Memo

To: Matt Janke and Chris Elliott, MR Erie, LLC
From: Hannah Hippely
Date: January 25, 2019
Re: SK-000978-2018 – Spring Hill Sketch Plan Application
cc: Deborah Bachelder

To: Hannah Hippely
From: Chad Schroeder, P.E., CFM, Development Engineer
Date: December 21, 2018
Subject: **Spring Hill Sketch Plan**
CC: Matt Wiederspahn
Wendi Palmer

Comprehensive Plan Map

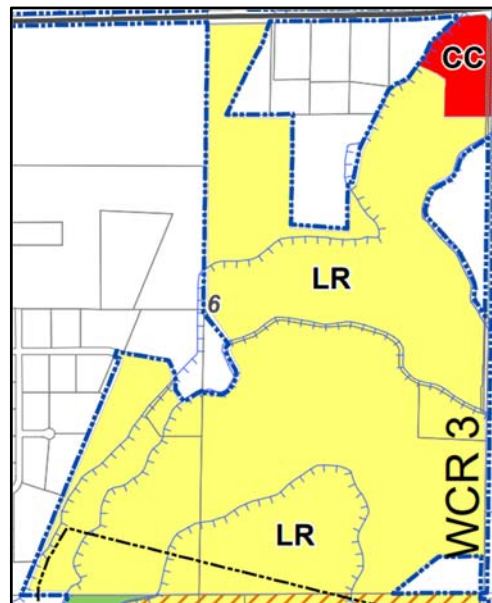
- a. All of the uses proposed by the sketch plan are permitted within the LR Zone District and the zoning allows for all of the land use designations of the Comprehensive Plan.
- b. The proposed sketch plan is not consistent with the Comprehensive Plan Agriculture (AG) land use designation for this property.
 - i. Approximately 70 acres in the south portion of the property is designated as Agriculture (AG) on the Comprehensive Plan. According to the Comprehensive Plan farming, ranching, and other agriculturally related uses and very low density rural residential uses

- are appropriate in this area. Also, lands designated Agriculture “serve a vital role in defining the history and character of Erie and should be maintained where viable, to serve as gateways and buffers, preserve vistas, and retain the desired character of the Town.” Within this area the plan shows the western edge, the areas adjacent to the western two ditches (Lower Boulder Ditch and the Boulder/Weld Ditch), as open space and develops the remainder at a density consistent with an LDR land use designation.

- ii. The LR Zone Designation does not negate the need for the subdivision to be consistent with the Comprehensive Plan. A Comprehensive Plan land use map change would need to be approved if the subdivision is not redesigned to be consistent with the Comprehensive Plan.

- c. It appears that over all residential densities comply with the Comprehensive Plan and Zoning Map.
 - i. Tract Q, which is located along the western edge of the development adjacent to the rural Weld County subdivision and the south east corner of the property are two areas designated RR on the Comprehensive Plan where residential densities of 0-2 dwelling units per acre (du/ac) and gross density not to exceed 1 du/ac is expected.

Zoning Map

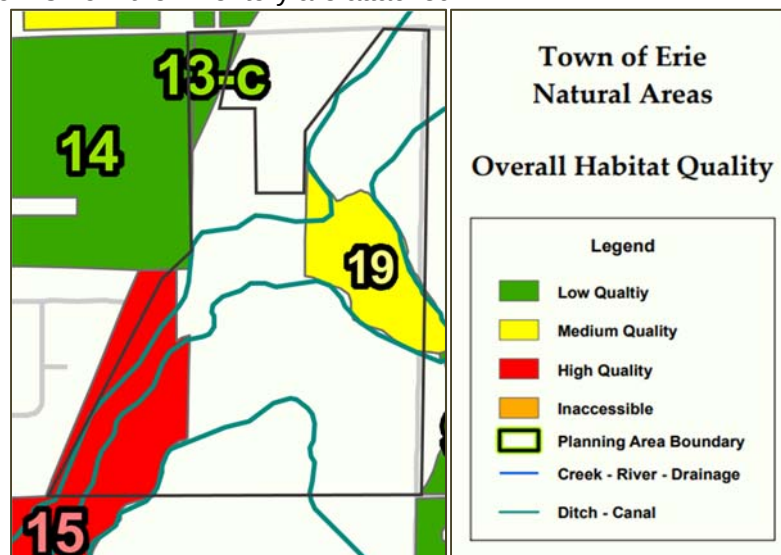
- d. The Comprehensive Plan and the Zoning Map show a flight cone associated with the Parkland Airport over southern portions of the property. The applicant will need to coordinate with the Parkland HOA as part of the preliminary plat process.

- e. As shown on the Comprehensive Plan, the sketch plan includes a school site in the south east portion of the site.
